### SECTION 00 91 11 - ADDENDUM NUMBER 3

Date: February 14<sup>th</sup>, 2025  
Project: NGFD English Road Station - Contracts DEFG  
Project Number: 20233530.0001

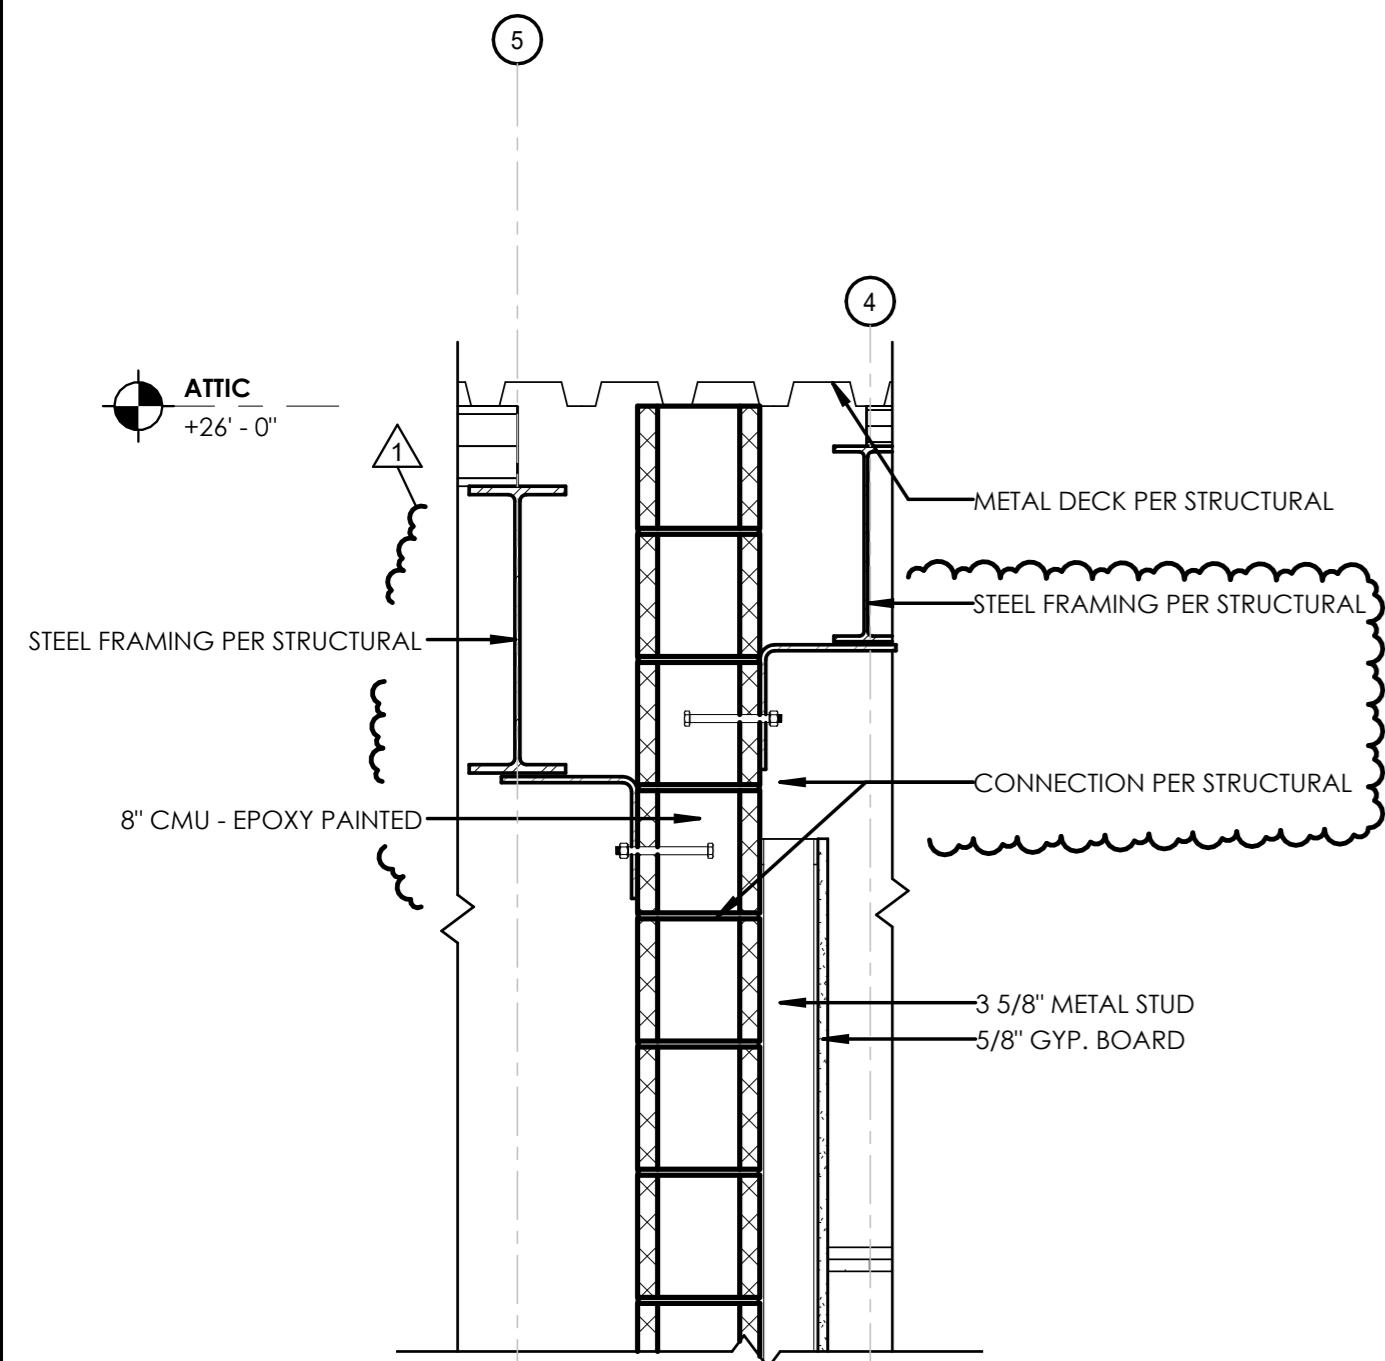
RFI ID	Subject	Question	Answer	From	Forwarded To	Rcv'd	Date Closed	Total Days
<b>PRFI-08-GC</b>	Cast Stone Clarifications	<p>Cast Stone 047200-1.01 lists "exterior wall units, including quoins" but there are none. All the elevations and wall sections indicate that the window sills are rowlock brick such as shown at 1/A315 and 2/A318. However, the window schedule shows all the windows in masonry getting a CAST STONE SILL per Sill Type 5 at detail 1/A602. Are the sills to be brick or cast stone?</p> <p>The window schedule on A602 indicates that the interior Type A windows shown at building section 2/A300 get cast stone sills per Sill Type 5 at detail 1/A602 but they are in CMU so that sill section is not accurate. If the interior Type A windows require cast stone sills, a new cross-section would need to be provided.</p> <p>The window schedule on A602 indicates that the Type H windows get cast stone sills but they are clearly shown with brick sills at 3/A319. Which is correct?</p> <p>The window schedule on A602 indicates that the Type F windows shown at East Elevation 1/A201 have no cast stone sills per Sill Type 5 at detail 1/A602 but that detail is not correct in that the Type F windows have brick directly under them, not EIFS as shown. Should the Type F windows get cast stone sills?</p> <p>If the window sills are to be cast stone, should the pier cap at 1 &amp; 4 &amp; 5 that is shown as brick also be made as cast stone?</p> <p>Should keystones at 3&amp;4/A319 and South Elevation 2/A200 be cast stone (perhaps these are the "quoins" mentioned at Cast Stone spec 047200-1.01)?</p>	<p>Cast Stone 047200-1.01 lists "exterior wall units, including quoins" but there are none. All the elevations and wall sections indicate that the window sills are rowlock brick such as shown at 1/A315 and 2/A318. However, the window schedule shows all the windows in masonry getting a CAST STONE SILL per Sill Type 5 at detail 1/A602. Are the sills to be brick or cast stone?</p> <p>The window schedule on A602 indicates that the interior Type A windows shown at building section 2/A300 get cast stone sills per Sill Type 5 at detail 1/A602 but they are in CMU so that sill section is not accurate. If the interior Type A windows require cast stone sills, a new cross-section would need to be provided.</p> <p>The window schedule on A602 indicates that the Type H windows get cast stone sills but they are clearly shown with brick sills at 3/A319. Which is correct?</p> <p>The window schedule on A602 indicates that the Type F windows shown at East Elevation 1/A201 have no cast stone sills per Sill Type 5 at detail 1/A602 but that detail is not correct in that the Type F windows have brick directly under them, not EIFS as shown. Should the Type F windows get cast stone sills?</p> <p>If the window sills are to be cast stone, should the pier cap at 1 &amp; 4 &amp; 5 that is shown as brick also be made as cast stone?</p> <p>Should keystones at 3&amp;4/A319 and South Elevation 2/A200 be cast stone (perhaps these are the "quoins" mentioned at Cast Stone spec 047200-1.01)?</p> <p>All window sills located at masonry to be rowlock brick. Pier caps to be rowlock brick. Please refer to Addendum 3 for associated drawings. All 4 keystones to be cast stone quoins, these are the only locations cast stone to be used.</p>	Kurt Van Heusen	Quille Hughes; Paul Lucas	2/10/2025	2/14/2025	5
